INDESIT company

BCB333AVEIC/HA

F048743

52220V0 Exploded views

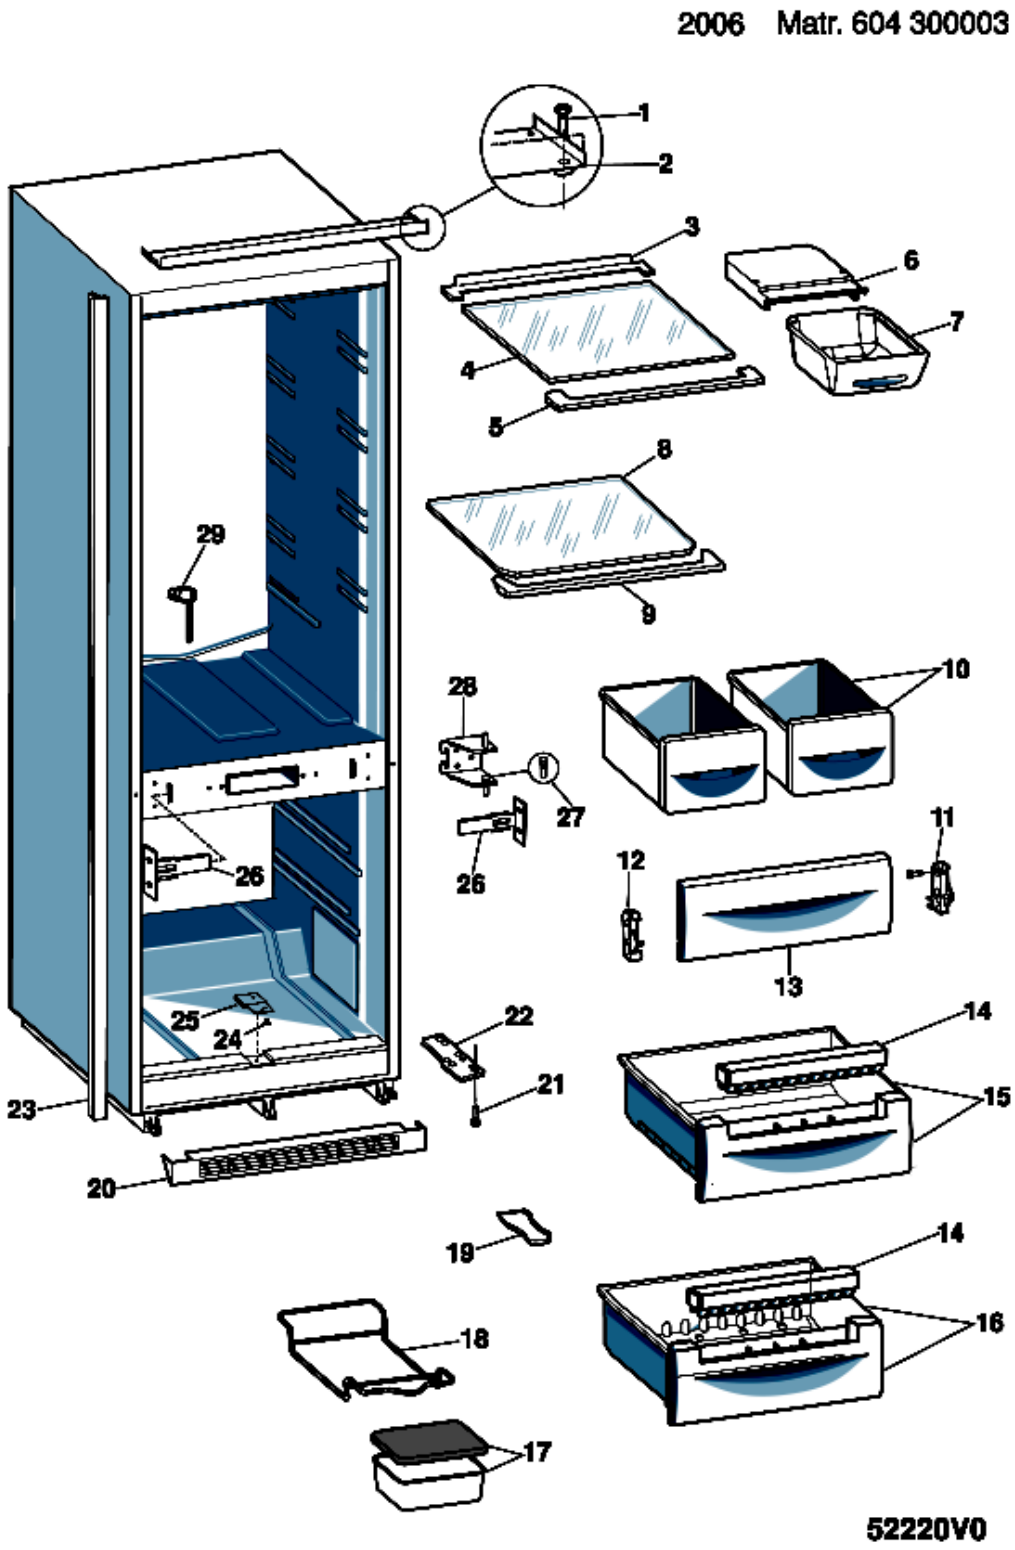
n3010j01: Colour Change of Internal Accessories

The colour of some of the internal shelves and accessories have changed to transparent. This affects models produced in Carinaro-

Manisa. Modification is functionally interchangeable therefore once the colour versions of the parts have depleted they will automatically substitute to its corresponding transparent parts. Some parts will have been made obsolete with no substitution.

Some parts have changed from Satin Finish to Shiny (Crystal) Finish. These parts include;
-Door Shelves
-Crisper Front Panels
-Freezer Drawer Front Panels
All pre-modification components will be managed till the end of stock and after they will be substituted with new version.

0522067: SEALS FOR DOORS FOAMED AS ONE PIECE

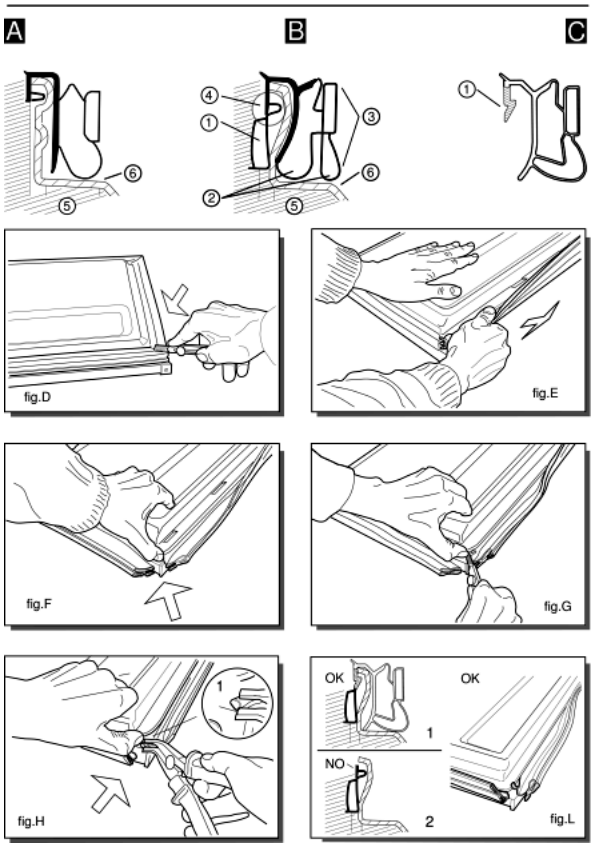
Various types of gaskets with different profile, as shown in figures (A) and (B), are used to fix the door (fig. A-5; B-5) and the inner door (fig. A-6; B-6) on the block foamed doors of combined freezers and refrigerators.
---Ilpea profile 245; 179; 412 (fig.A)
---Ilpea profile 287 (fig.B)
When replacing gaskets with profiles 245; 179; 412 these are fixed with screws (2 per corner) to the door.
Gaskets with profile 287 can not be used as spare parts but are designed to house the Ilpea type 900 gaskets (see figure C).
When replacing the gasket (287), once it is removed you will find a pocket (fig. B-1) between the door and inner door.
The rigid tooth (fig.C-1) of the gasket (900) is inserted inside between the pocket and the inner door, doing away with the need for screws.
Gasket with profile 287 is easy to identify since it has an exterior double edge (fig.B-2) which acts as a cushion when the door is closed.

To replace this gasket, follow these steps:
---Dismount the door and cut the four corners of the gasket along the joint (fig.D);
---lift the gasket and pull it carefully along its full length without tearing it (fig.E).
The purpose here is to detach the inner door slightly from the foam along the exterior edge for a depth equal to that of the gasket (fig.B-3);
---lift the corner of the inner door slightly, prising it up with your thumb (fig.F). Do not use a tool which might break the inner door;
---continue cutting the gasket inside the inner door for about 6 mm (fig.G);
---push in the tip of the pliers (type USAG N131) and pull outwards until you see the top edge of the pocket (fig. B-4) which is empty (fig.H-1);
---if you carry out this operation correctly (fig.L) you will be able to pull off the top edge of the pocket for the full length of the door.
If the gasket tears before the top edge (fig. L-2) you should repeat this operation from the other corner of the door.

---once the gasket (287), has been removed the space above the pocket (fig. L-1) can house the rigid tooth (fig. C-1) of the gasket 900.
When you fit this gasket ensure that it lies flush against the edge for the full length of the door.
If the rigid tooth is difficult to fit, eliminate any residues of foam between the door and the inner door in the gasket area.
fig.5131549A
